Groundwater Application Review Summary Form

Application # G- 18854 re-review

PUBLIC INTEREST REVIEW FOR GROUNDWATER APPLICATIONS

TO: Water Rights Section
 FROM: Groundwater Section Travis Brown Date 11/22/2022
 Reviewer's Name
 SUBJECT: Application G- 18854 Supersedes review of 9/23/2019
 Date of Review(s)

Projected Well-to-Well Interference with MARI 63710

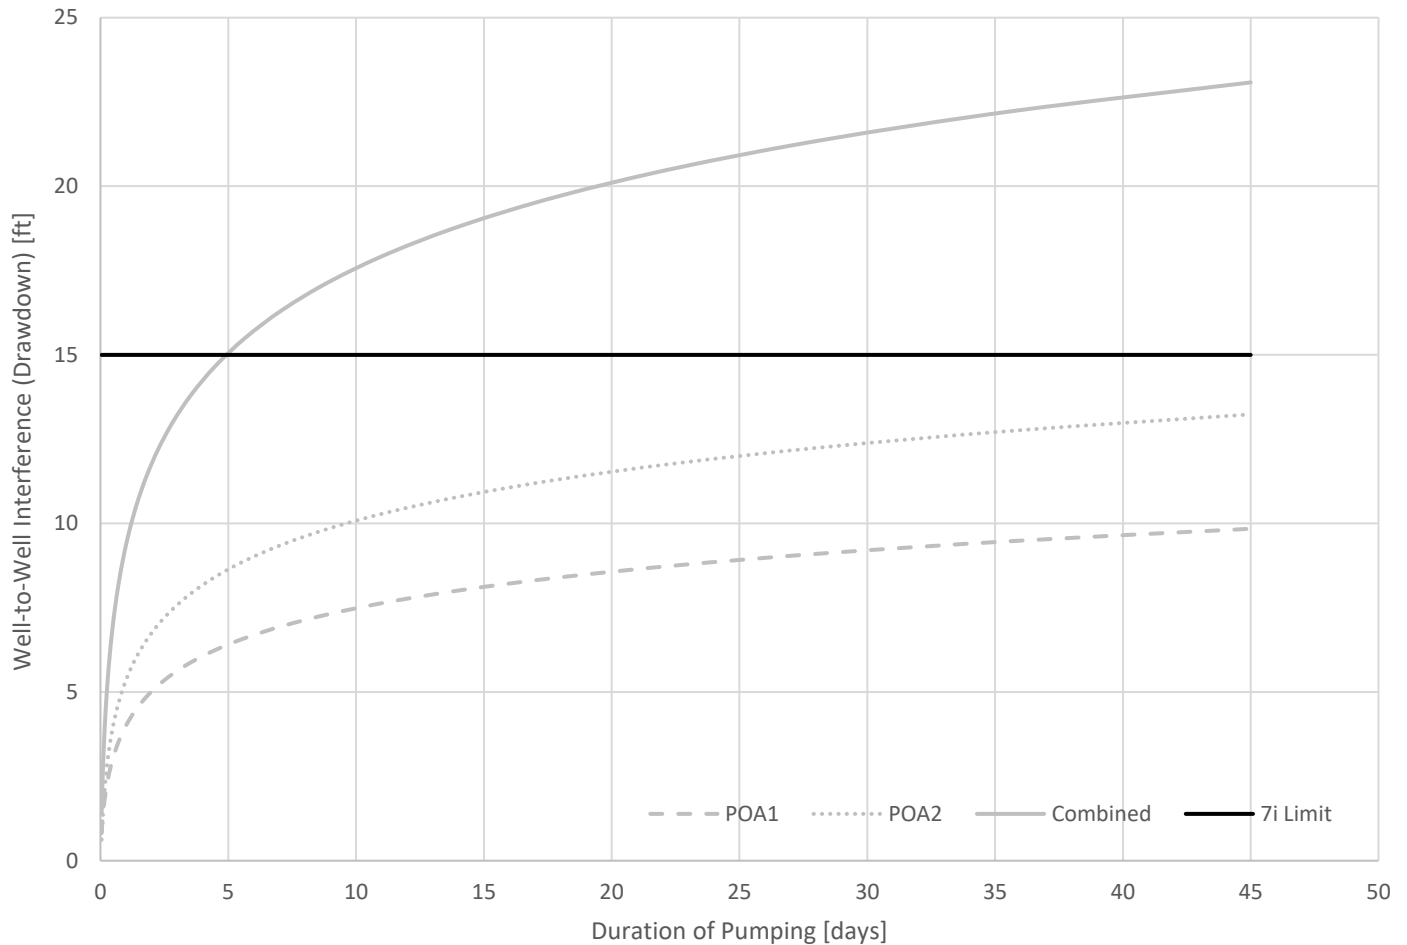
The nearest groundwater users to the proposed POA are MARI 63710, ~280 ft northwest of POA 1 and ~670 ft southwest of POA 2, and MARI 59485, ~500 ft east of POA 1 and ~570 ft south of POA 2. Both MARI 63710 and MARI 59485 are exempt domestic wells. To assess the degree of drawdown, analyses were conducted for the proposed use using the Theis equation for drawdown in a confined aquifer (see attached Theis Drawdown Analyses). **Results indicate that the proposed use could cause well-to-well interference with MARI 63710 and MARI 59485 to exceed 15 ft of drawdown within less than 1 week of continuous operation at the maximum proposed rate (0.0935 cfs or ~42 gpm), which would require curtailment of the proposed use per Condition 7i, above. Therefore, the proposed use will not likely be available within the capacity of the groundwater resource.**

Distance to Barrier/Boundary (aquifer boundary/contact) from Pumping Well (x):

POA 1 (MARI 14751) = 820 ft

POA 2 (MARI 14754) = 600 ft

Distance from Pumping Well to Affected Well (MARI 63710) (x,y):

POA 1 (MARI 14751) = 400 ft, -260 ft

POA 2 (MARI 14754) = 0 ft, 675 ft

Pumping Rate (Q):

POA 1 (MARI 14751) = 18 gpm [proposed rate]

POA 2 (MARI 14754) = 24 gpm [proposed rate]

Aquifer Transmissivity (T) = 2,618 gpd/ft (350 ft²/day) [based on data from nearby pumping tests]

Aquifer Storativity (S) = 7×10^{-5} [MARI 65954 aquifer test]

Total Pumping Time = 45 days [time to reach maximum annual volume, 8.4 af/year]

Projected Well-to-Well Interference with MARI 59485

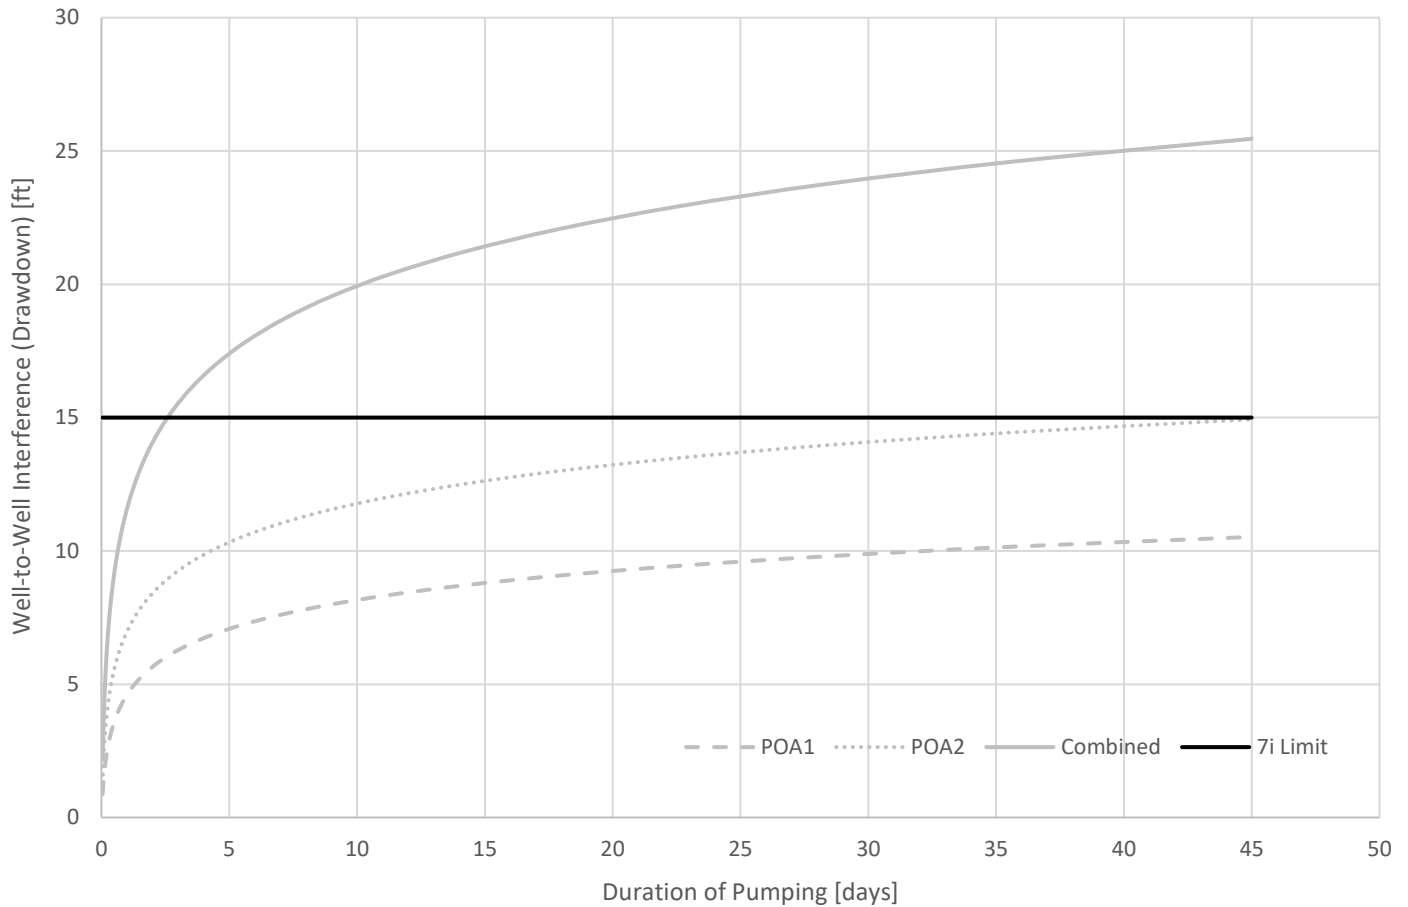
Distance to Barrier/Boundary (aquifer boundary/contact) from Pumping Well (x):

POA 1 (MARI 14751) = 820 ft

POA 2 (MARI 14754) = 600 ft

Distance from Pumping Well to Affected Well (MARI 59485) (x,y):

POA 1 (MARI 14751) = -320 ft, -340 ft

POA 2 (MARI 14754) = -530 ft, 240 ft

Pumping Rate (Q):

POA 1 (MARI 14751) = 18 gpm [proposed rate]

POA 2 (MARI 14754) = 24 gpm [proposed rate]

Aquifer Transmissivity (T) = 2,618 gpd/ft (350 ft²/day) [based on data from nearby pumping tests]

Aquifer Storativity (S) = 7x10⁻⁵ [MARI 65954 aquifer test]

Total Pumping Time = 45 days [time to reach maximum annual volume, 8.4 af/year]
